HISTORIC AND DESIGN REVIEW COMMISSION

HDRC CASE NO: 2017-228
ADDRESS: 223 W HOLLYWOOD AVE
LEGAL DESCRIPTION: NCB 6459 BLK 10 LOT 10, 11 & E 12.5 FT OF 9
ZONING: R-5 H
CITY COUNCIL DIST.: 1
DISTRICT: Monte Vista Historic District
APPLICANT: Bernice Beck
OWNER: Bernice Beck
TYPE OF WORK: Construction of a rear storage shed

The applicant is requesting a Certificate of Appropriateness for approval to build a storage shed in rear of property with materials similar to those found on primary structure.

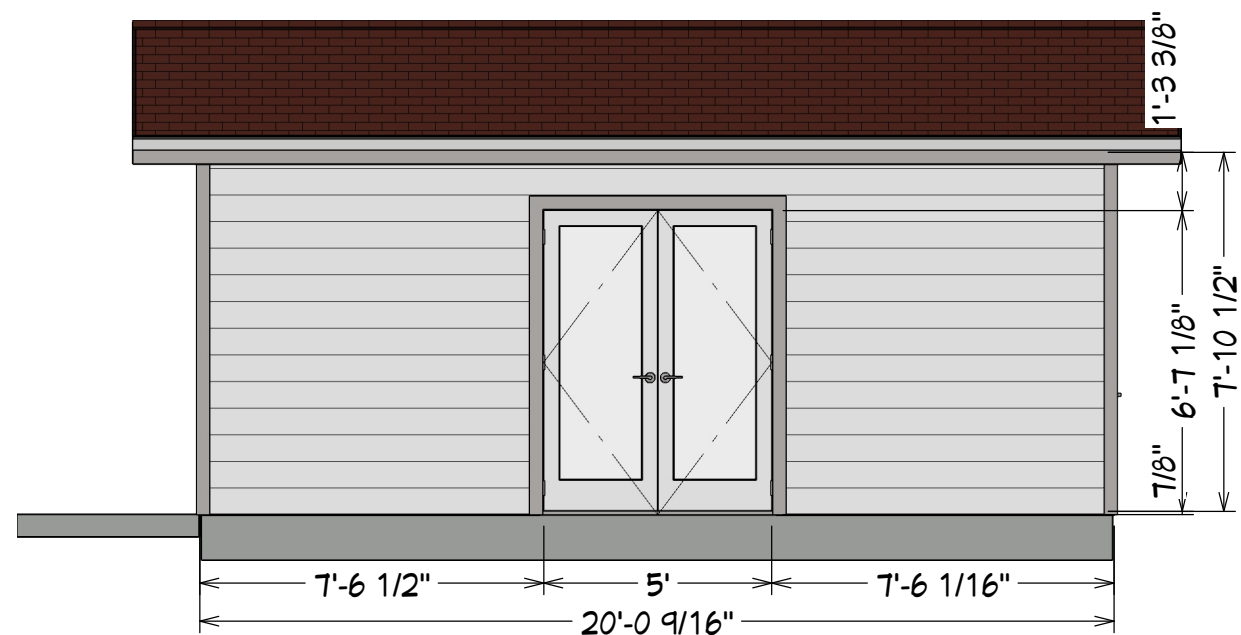
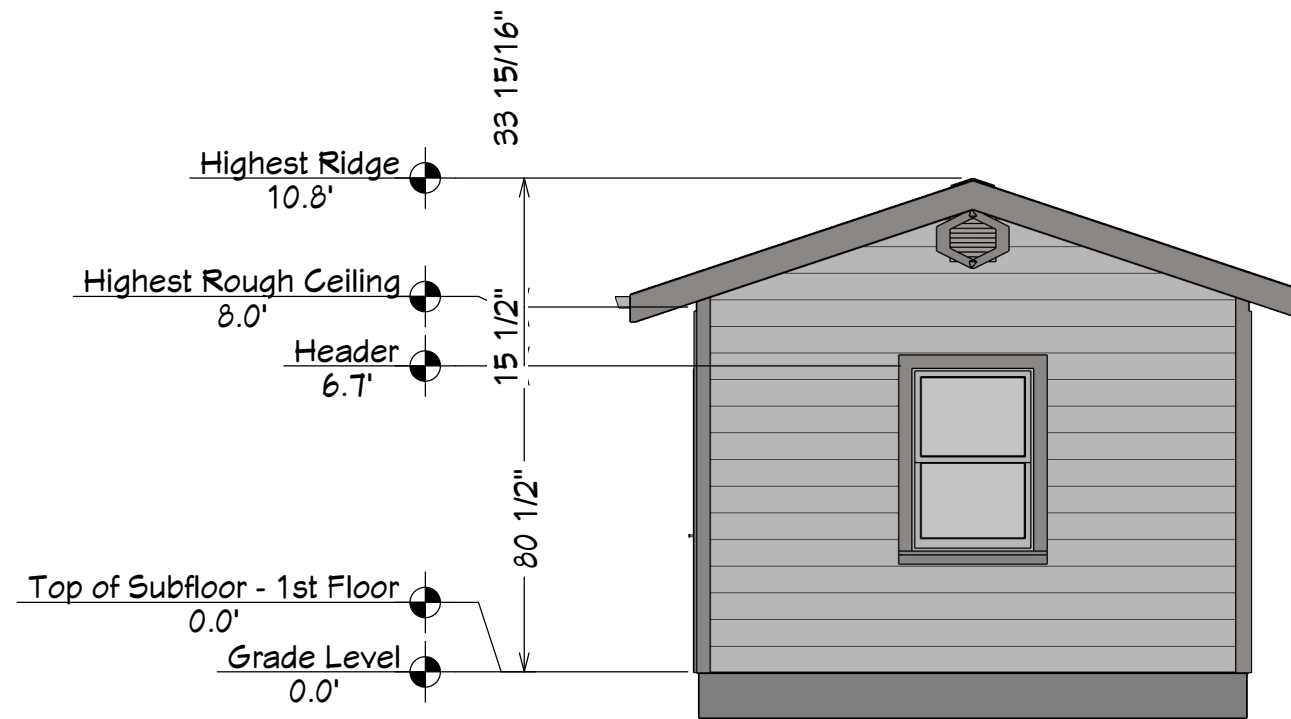
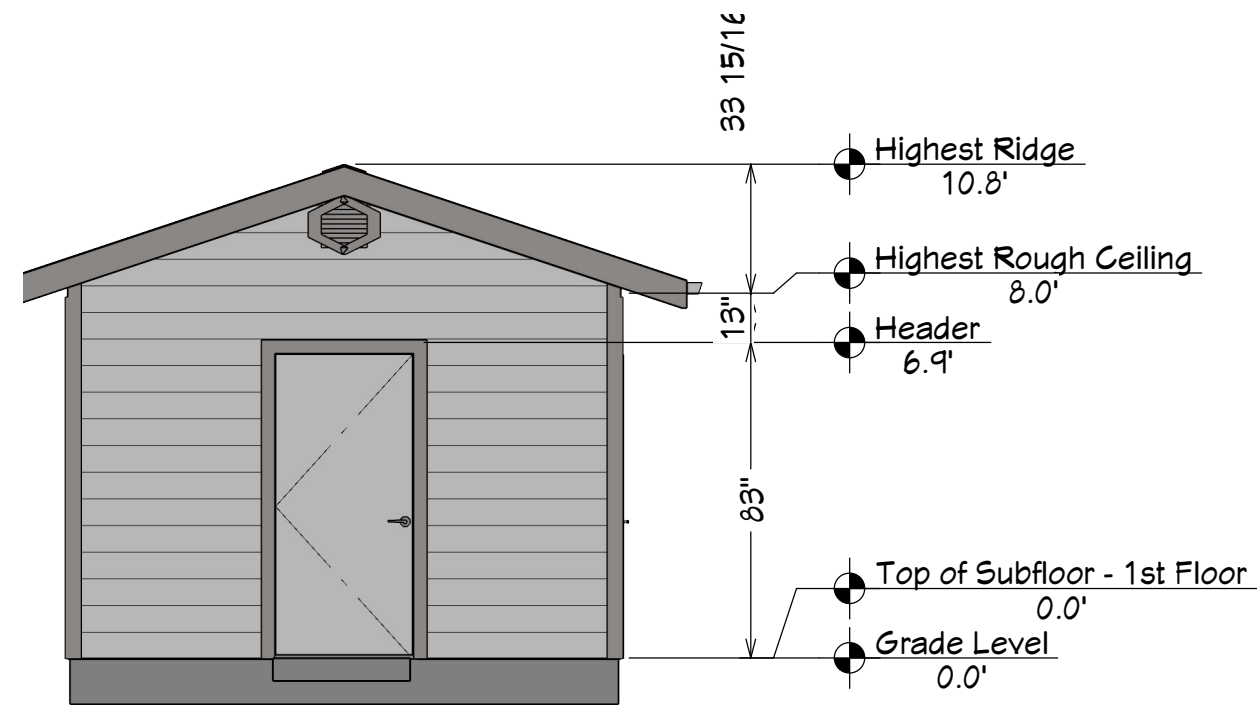
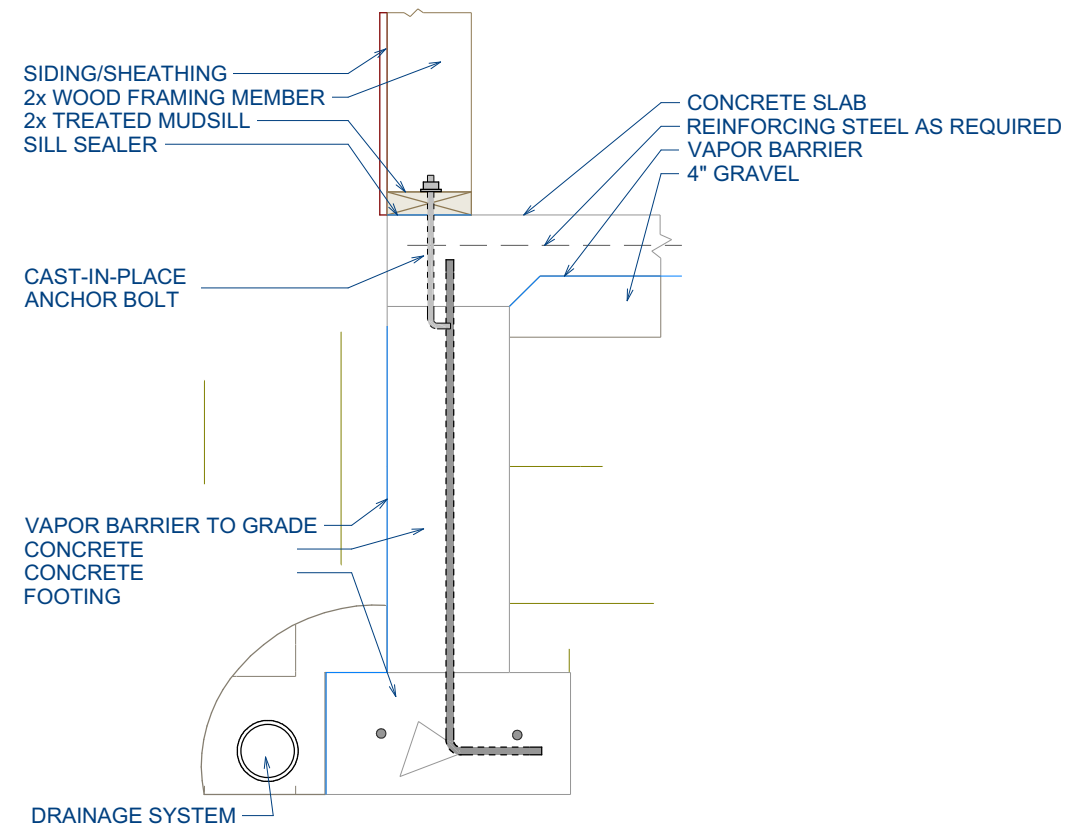
- d. **WALL MATERIAL** – Per the Historic Design Guidelines, new outbuilding should relate to the period of construction of the primary structure through use of compatible materials and simplified details. The primary structure is a contributing structure to the district and its stucco façade is a character defining feature of the design. Staff finds the use of hardi board siding inconsistent with the guidelines.

- e. **WINDOWS AND DOORS** – The applicant has proposed to use wood windows and a wood door for fenestration in the new rear structure. The guidelines for garages and outbuildings recommend materials complementary to the primary structure as well as the district. Staff finds the use of wood windows and doors consistent with the guidelines and the materials of the district.

- f. **ROOF** – The guidelines state that materials should complement the type, color, and texture of materials traditionally found in the district. Staff finds the proposal of using modern shingles in a terracotta red color complementary to the primary structure and consistent with the guidelines.

- i. Stucco be used on all four facades of the structure in lieu of hardi board siding,
- ii. The applicant submits specifications and manufacturer information for the proposed roof shingles and proposed wood windows and doors to staff for final approval before receiving a Certificate of Appropriateness.
